THE HOTEL AT FOUNDRY PLACE, "LOT 3": 165 DEER STREET, ASSESSORS MAP 125 LOT 17, AND RELATED IMPROVEMENTS TO LOTS 2, 4 AND 5

SITE PLAN REVIEW

COVER SHEET

3.4

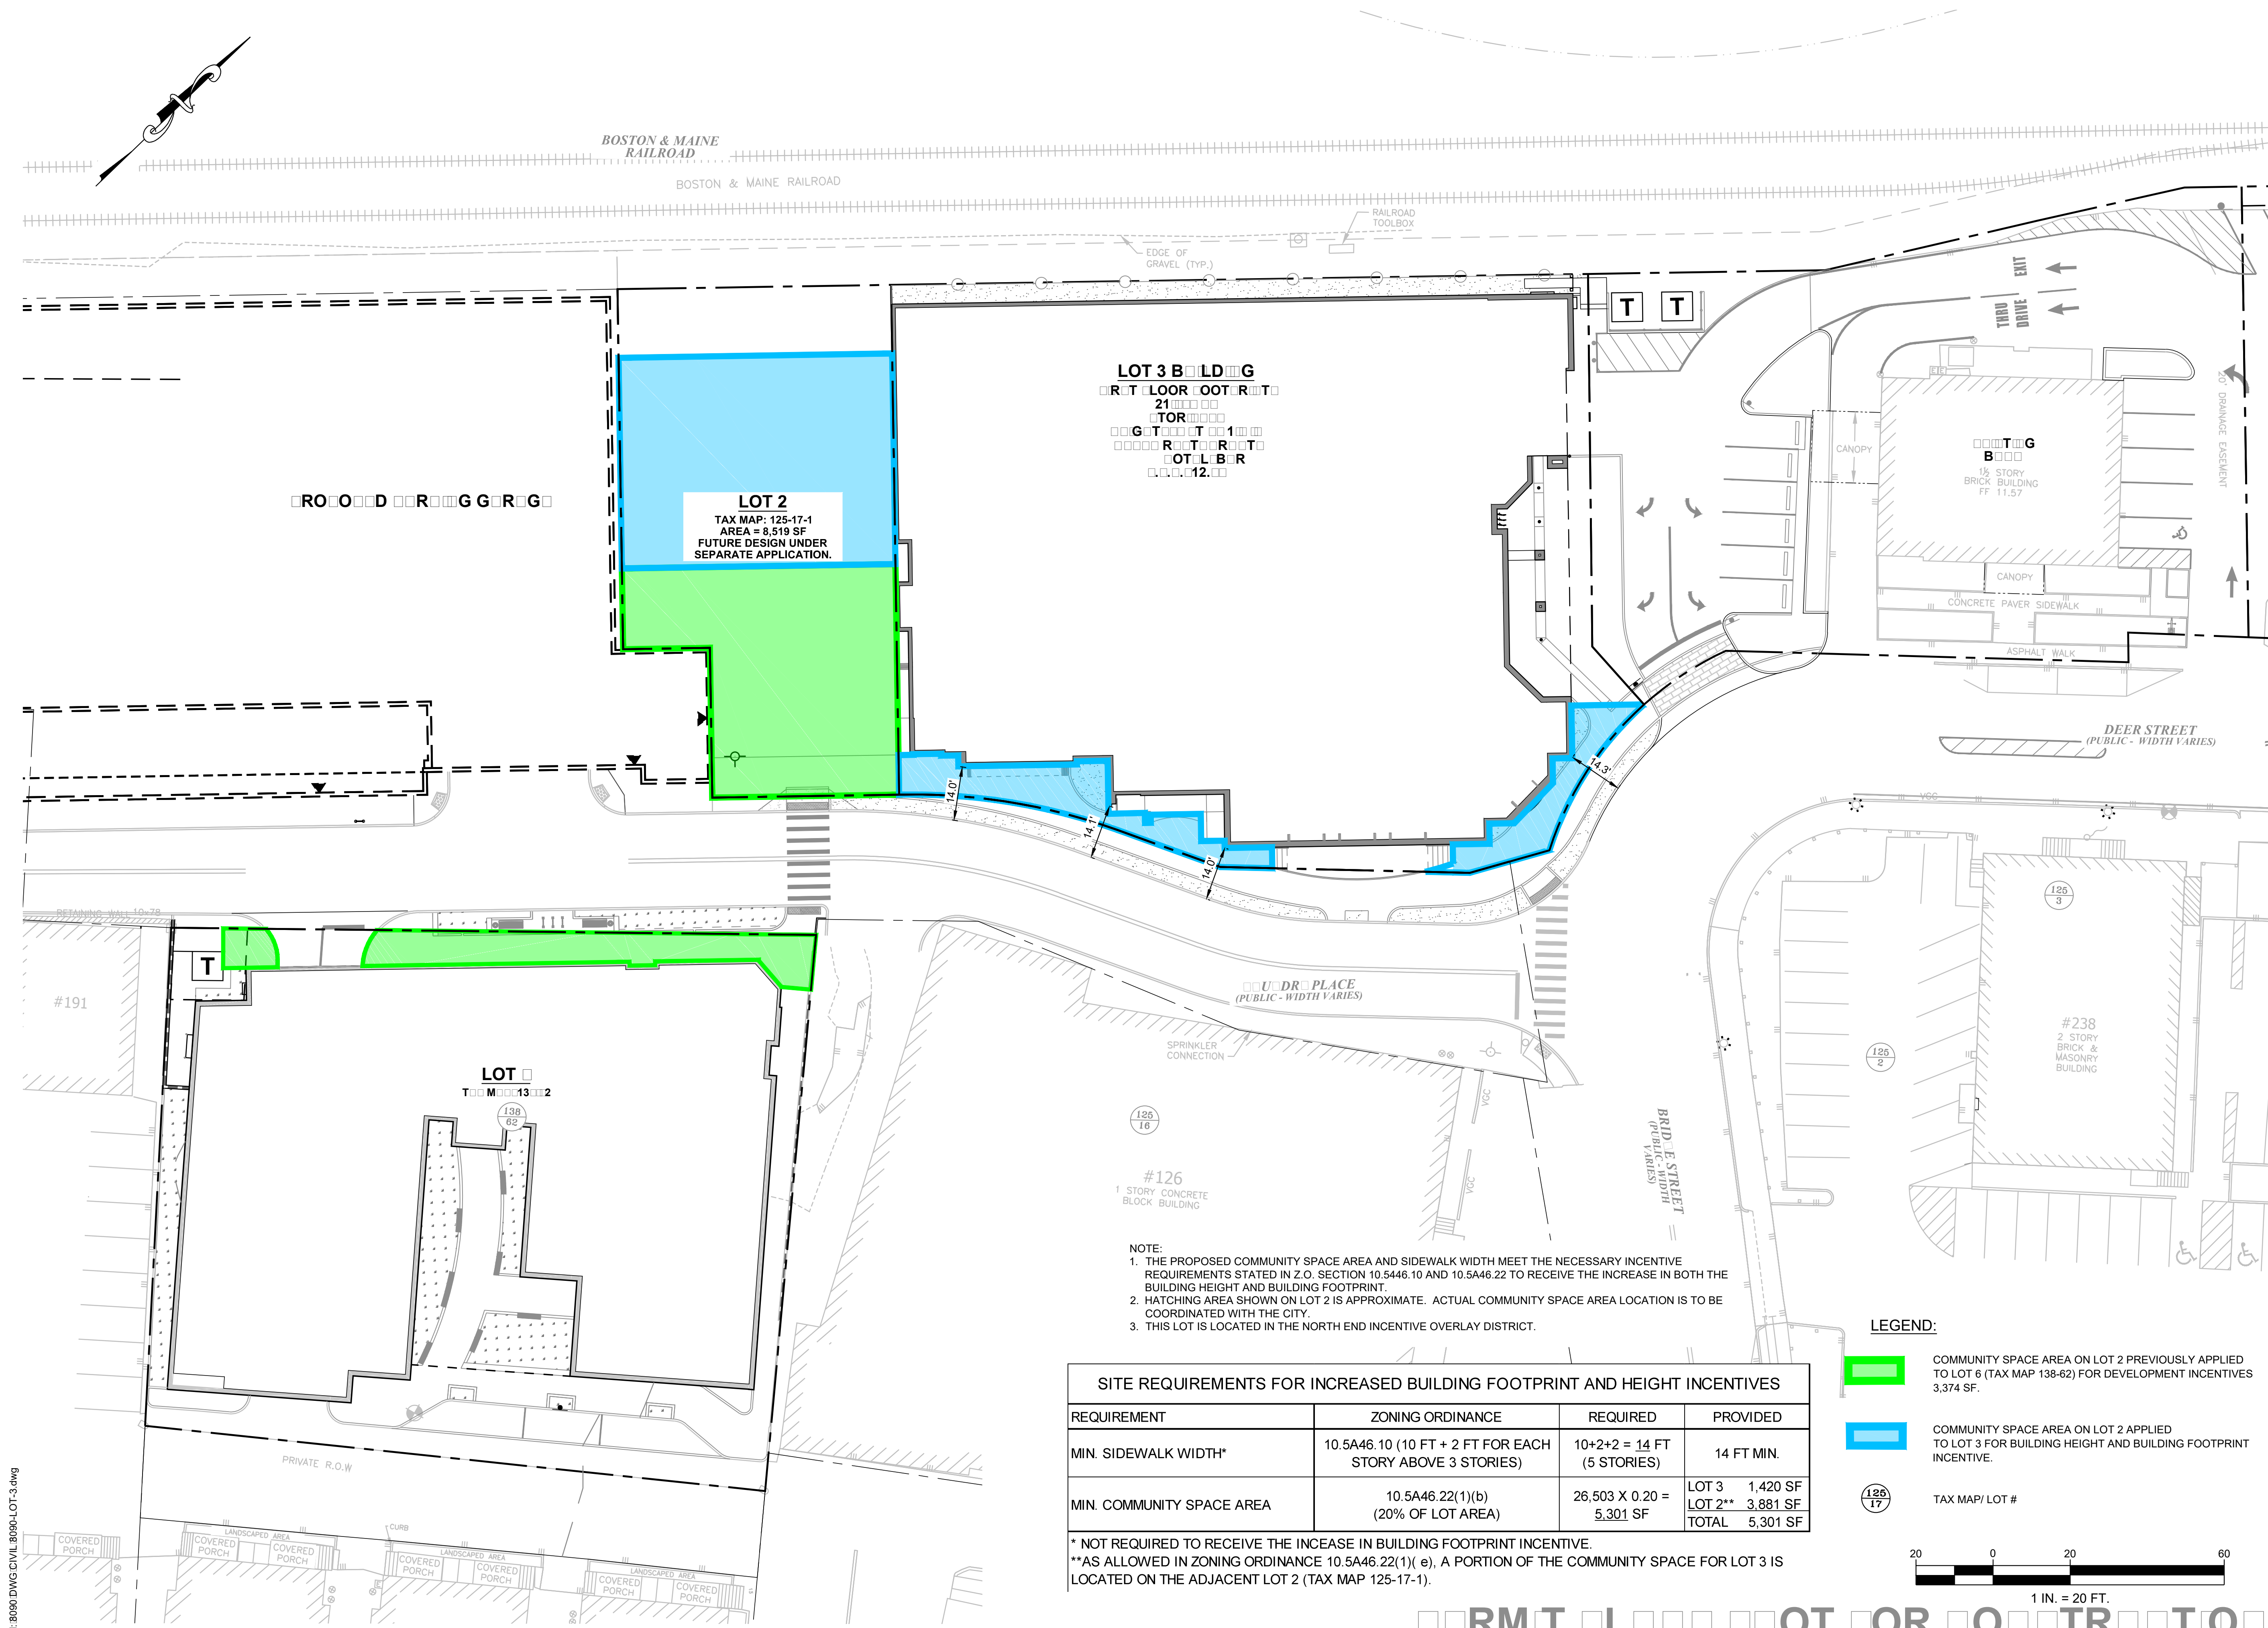
Geolinsight's previous and current drawing (Sheet C3.4) that addresses Community Space identifies what areas of the Foundry Place, LLC Lot 2 property were utilized by DSA for Lot 6 and will be utilized by Foundry Place, LLC for Lot 3. Because Lot 3 and Lot 6 will be counting some of the Lot 2 space toward development incentives, a formal arrangement is necessary to keep the Lot 2 area as Community Space in the future. With regard to the remaining space on Lot 2 that has not yet been appropriated for other future incentives, Foundry Place expects to reserve the right to use the space for future incentives or assign that right to DSA. However, the entirety of Lot 2 is still planned to be transferred to the City by Foundry Place, LLC at the end of the development process, whether there is unencumbered space remaining on Lot 2 at the time of the transfer or not.

26	Revise colors and locations of Open Space and Community Space sheets.	Addressed	Community Space and Open Space illustrations (Sheets C3.3 and C3.4) were updated for clarity.
27	Define how "unclaimed" portion of Community Space will be assigned.	Addressed	Addressed in cover letter. Area will be banked for future use as Community Space by DSA if possible, but will be turned over to the City with the remainder of the lot area.
28	City asked for Lot 2 frontage "surety."	Unresolved	Issue to be discussed further with City at the January 2, 2018 Hearing.
28	Define whether benches and other streetscape features are consistent with City specifications.	Addressed	Benches and other streetscape features will be consistent with City specifications.
29	Because City cannot access railroad side of building, the High-Rise provisions of the Code become effective which will mean pressurized sprinklers in stairwells and sprinklers may be required for lifts.	Pending	If required by Code, the required sprinklers will be provided.
